# TECH BULLETIN

# #33

## PRODUCT UPDATE: 50-1403 Flange Face

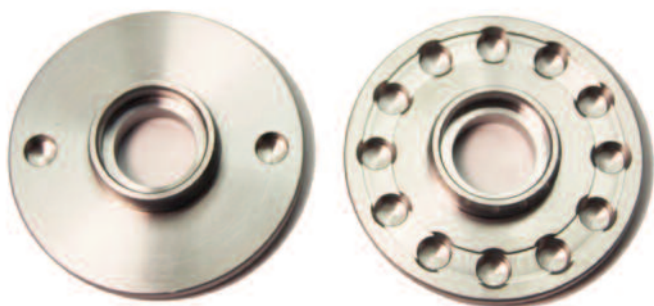
Pro-Cut has updated **50-1403**, the Flange Face. The old unit had two pilot holes where the adapter pin fit; the new unit has 12 holes and a channel for the adapter pin to ride until it beds into one of the holes. The revision allows for easy mating of the lathe between the flange face and the adapter pin, increasing efficiency of setup.

**Note:** All lathe models manufactured after 2/1/13 have the new style flange. The 50-1403 can only be used with the 50-1400 bolt-on flange.
